Access Compliance Report

Public Rights-of-Way

(Curb Ramps)

Intersection ID: 20221	Main Street: BARCLAY_DOWNS_DR	Cross Street: FAIRVIEW_RD	Location: NW
ADA ID: 53EED068F33B	Ramp Type: PerpDiag	Initial Pass/Fail: Fail	Overall Compliance: No
			Severity Score: 46.25

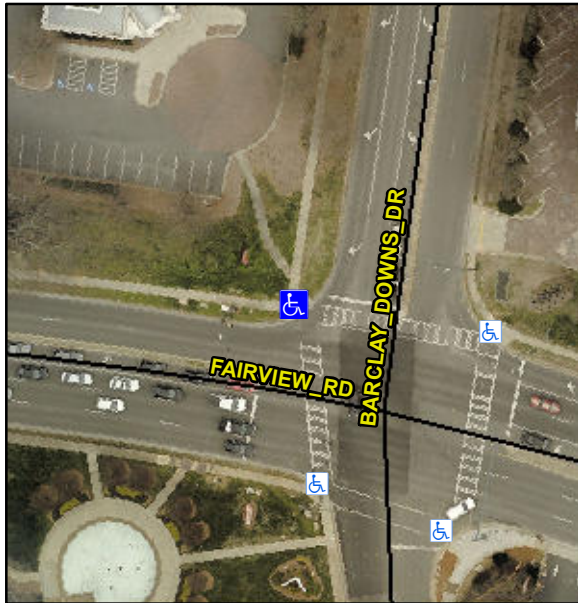
Not Found, R304.5.1, R304.2.2, R304.5.3

Compliance	Description	Data	Compliance	Description	Data
N/A	Ramp Length (in)	52.0	No	Ramp Slope (%)	13.5
No	Ramp Width (in)	47.5	No	Ramp XSlope (%)	6.5
N/A	Flare Type LT	N/A	N/A	Flare Type RT	N/A
N/A	Flare Slope LT (%)	N/A	N/A	Flare Slope RT (%)	N/A
N/A	Flare Traversable LT?	N/A	N/A	Flare Traversable RT?	N/A
N/A	Landing Length (in)	N/A	N/A	DWS Provided?	N/A
N/A	Landing Width (in)	N/A	N/A	DWS Contrast?	N/A
N/A	Landing Slope (%)	N/A	N/A	DWS Length (in)	N/A
N/A	Landing X Slope (%)	N/A	N/A	DWS Full Width?	N/A
N/A	Landing Curb? (Y/N)	N/A	N/A	DWS Offset (in)	N/A
N/A	Shared Landing?	N/A			
N/A	Gutter Ponding?	N/A	N/A	Gutter Slope (%)	N/A
N/A	Gutter Lip Ht (in)	N/A	N/A	Gutter X Slope (%)	N/A
N/A	Painted X Walk1?	Yes	N/A	Painted X Walk2?	Yes
	X Walk 1 Direction	To S		X Walk 2 Direction	To SE
N/A	X Walk 1 Width (in)	105.0	N/A	X Walk 2 Width (in)	110.0
	X Walk 1 Slope (%)	2.2		X Walk 2 Slope (%)	2.0
	X Walk 1 X Slope (%)	2.9		X Walk 2 X Slope (%)	3.4

Remove & Replace Curb Ramp With Two New Directional Ramps or Equivalent.
